Attorney Docket No.: C6656(C)  
Serial No.: 10/748,038  
Filed: December 30, 2003  
Confirmation No.: 6775

**Amendments to the Drawings:**

### **REMARKS**

**FIG. 1**

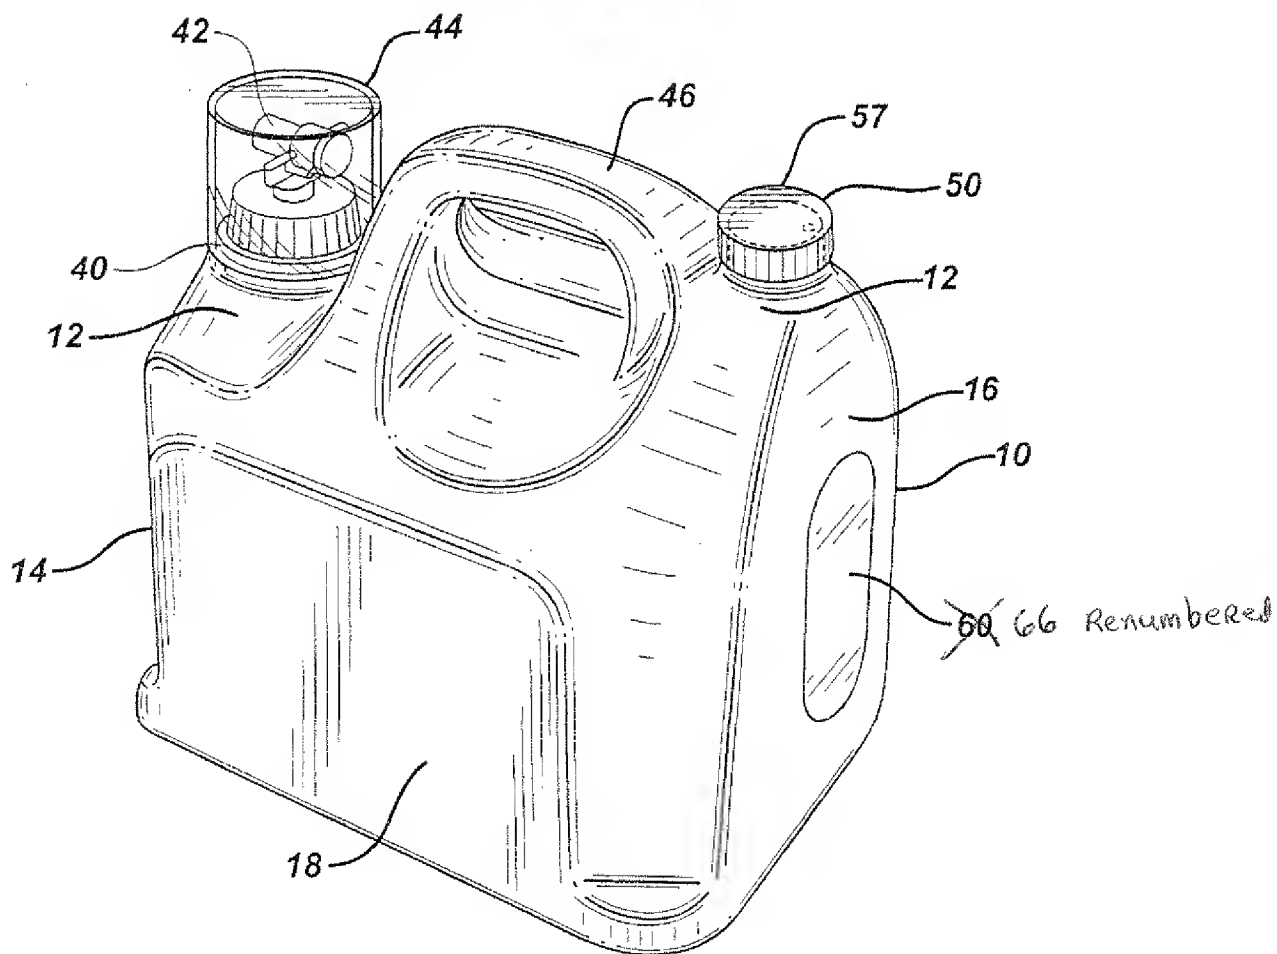
The attached sheets of drawings include changes to Figs. 1, 2 and 4. These sheets, which include Figs. 1, 2 and 4, replace the original sheets including Figs. 1, 2 and 4. In Figures 1, 2 and 4, element 60 has been changed to 66.

**FIG. 2**

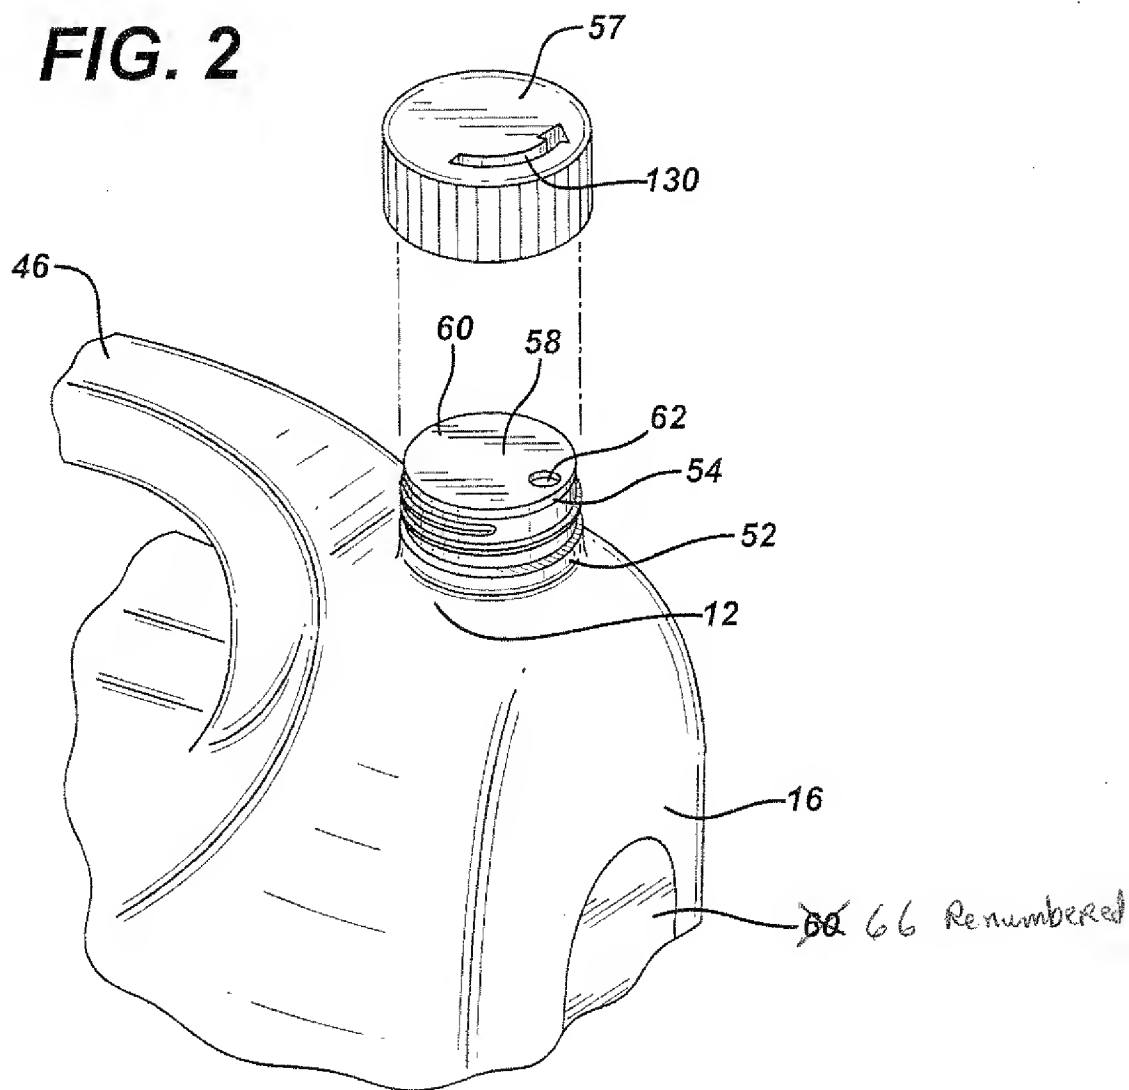
Independent claim 1 has been amended to incorporate original claims 3 and 4. Further, claim 1 has been amended to identify that the aperture in the patch is positioned off-center from a central point of the patch. Figures 2 and 4 support the off-center arrangement of aperture 62. Independent claim 9 has been similarly amended.
